## PLANNING BOARD

To: Chair Mazer & Members of the Planning Board  
From: Charles Tetelman  
Date: June 23, 2023  
Re: 70 Thames Street / 100 Fore Street  
Project ID: PL-002437-2023  
CBL: 019 A008001, 019 A002001  
Meeting Date: June 27, 2023

144 Fore St. OZ, LLC has submitted a Major Site Plan application to facilitate the construction of a 72,857 square foot, three-story mixed-use building at 70 Thames Street and 144 Fore Street. The building includes corporate office space for WEX, a third-floor restaurant, and first-floor retail space. Additionally, the application includes plaza and park spaces containing five, 256 square foot buildings intended as business incubator spaces. This application is being referred to the Planning Board for compliance with the City of Portland's Land Use Code Site Plan Standards, section 14.6.

**L2**

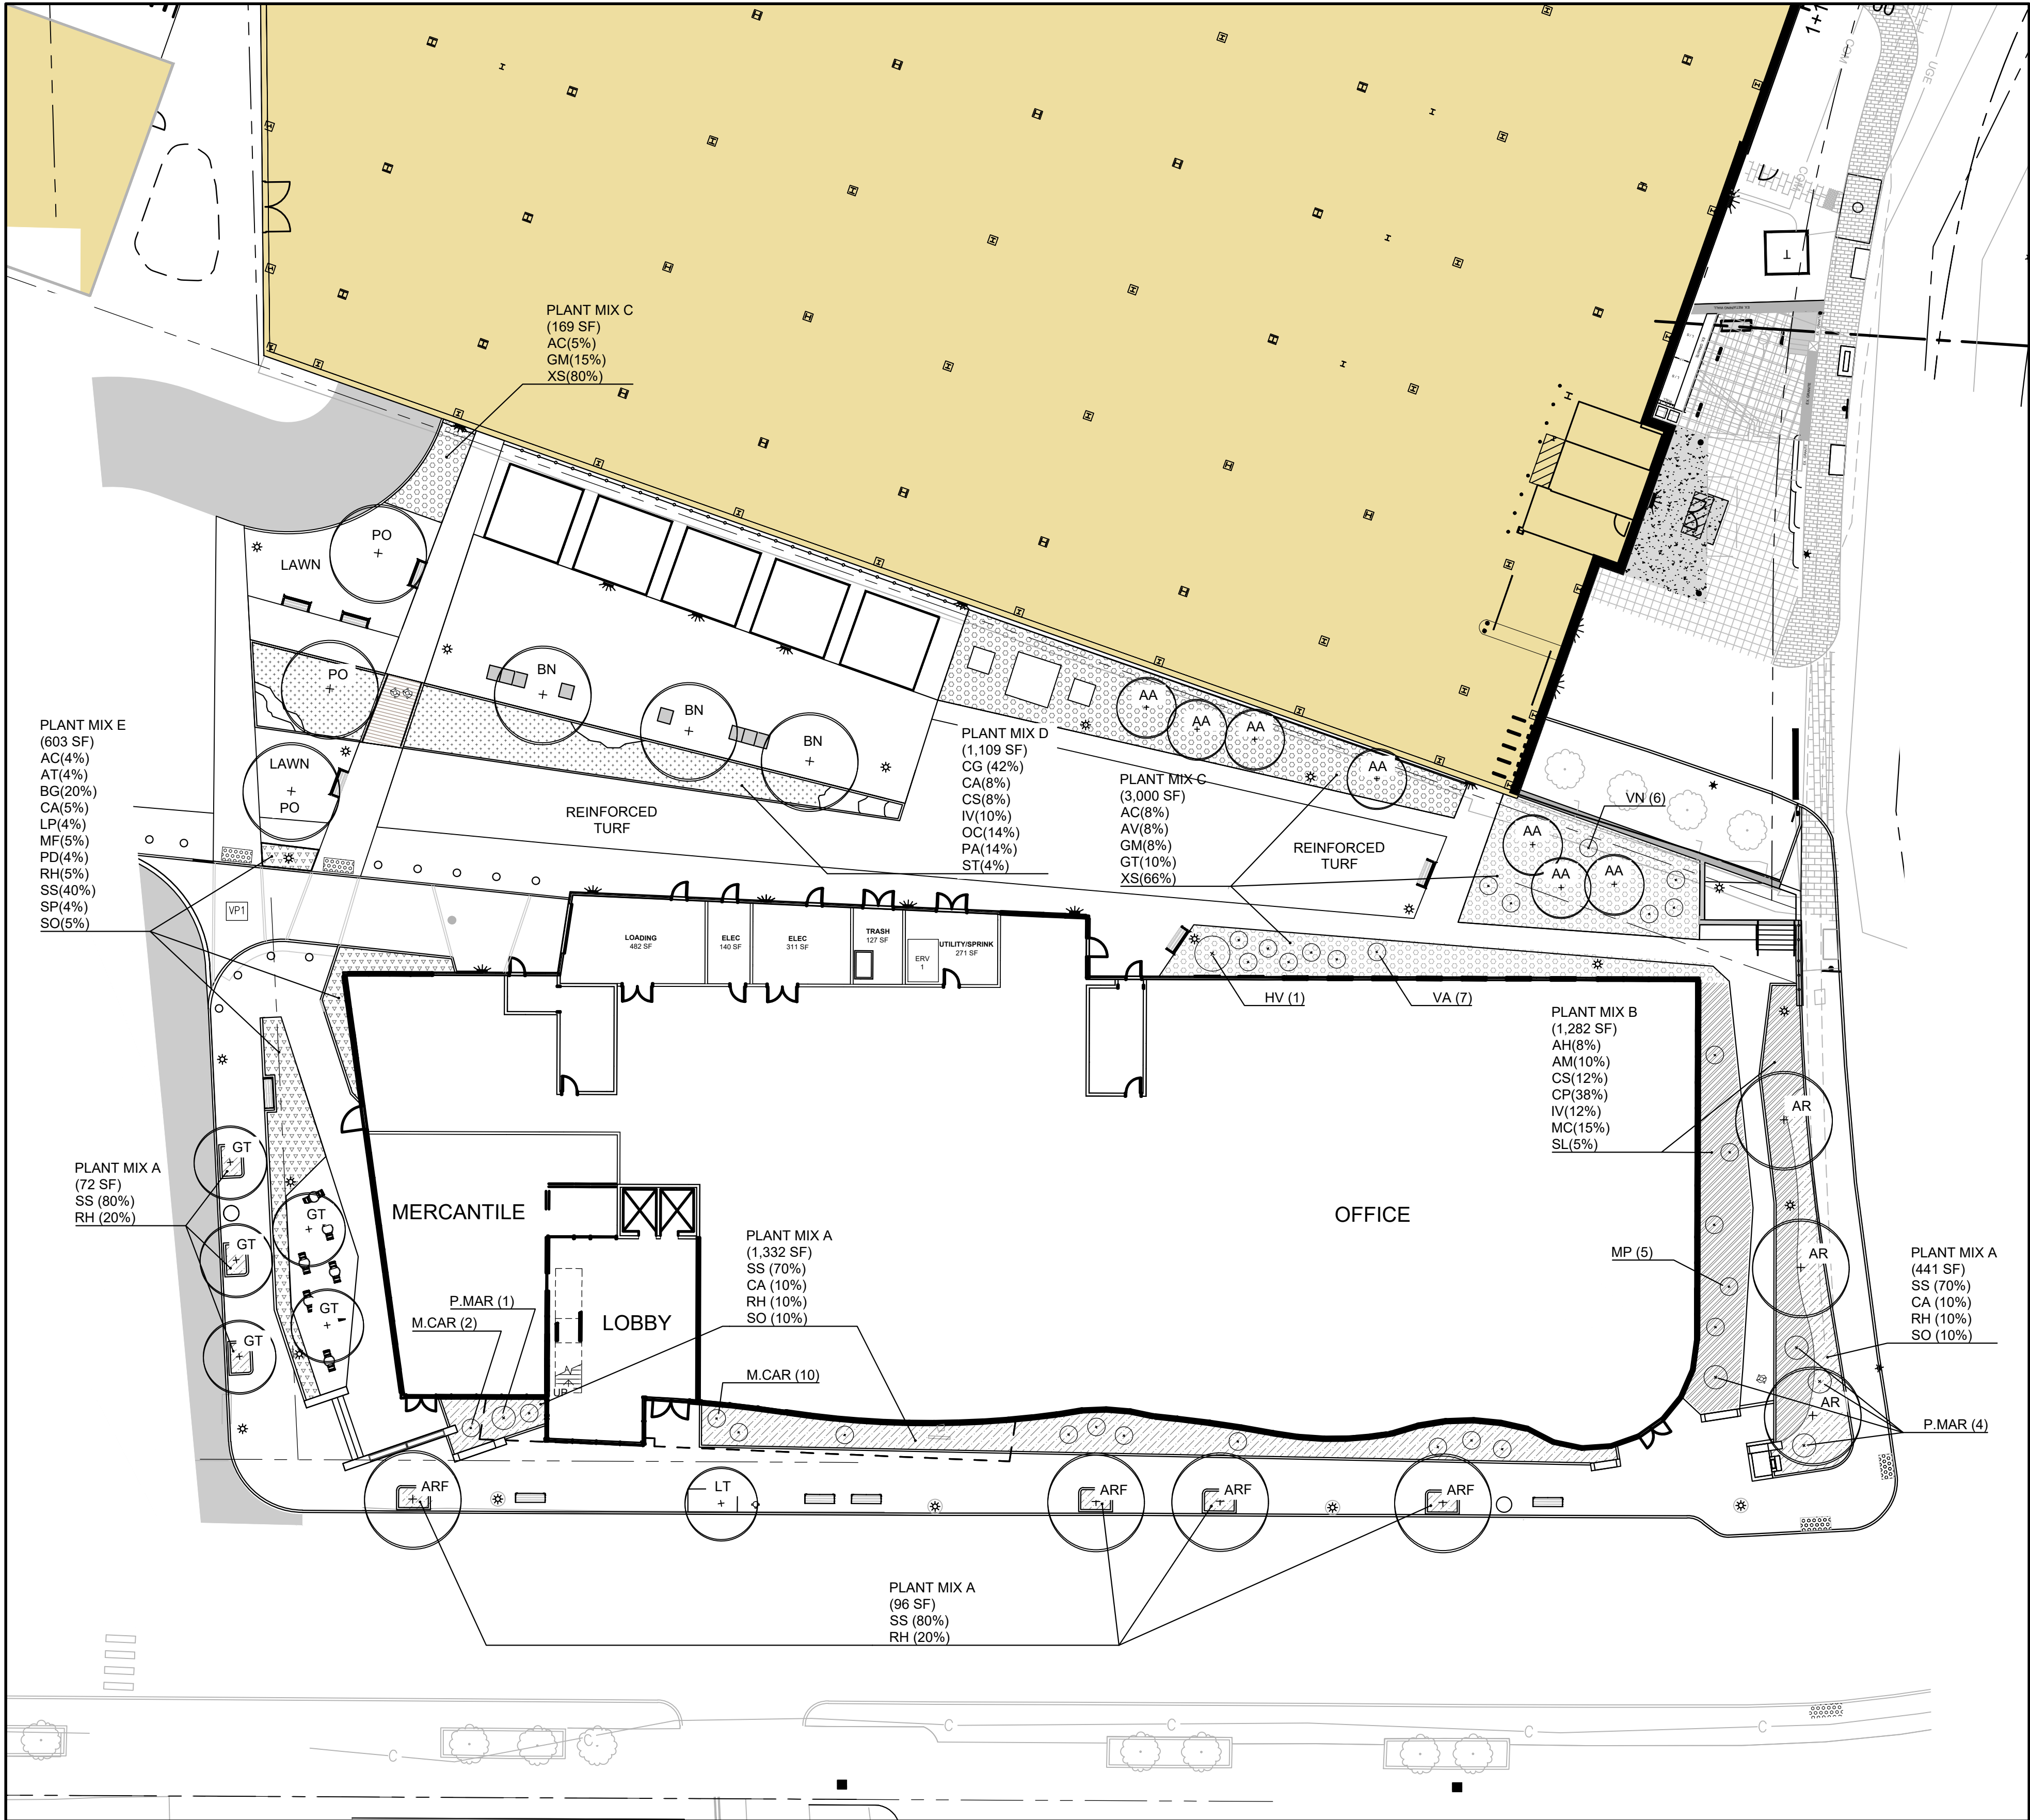
- Sheet L2 current landscape plan proposes numerous Maples as street trees. Maples as a genus are currently very over-represented in the City's street tree canopy. The City Arborist would prefer to see non-maples being planted on Thames to increase the Portland's urban canopy resilience against pests and disease. Tulip Poplars could be a good choice for the Thames Street frontage.

30. *Sheet L2 current landscape plan proposes numerous Maples as street trees. Maples as a genus are currently very over-represented in the City's street tree canopy. The City Arborist would prefer to see non-maples being planted on Thames to increase the Portland's urban canopy resilience against pests and disease. Tulip Poplars could be a good choice for the Thames Street frontage.*
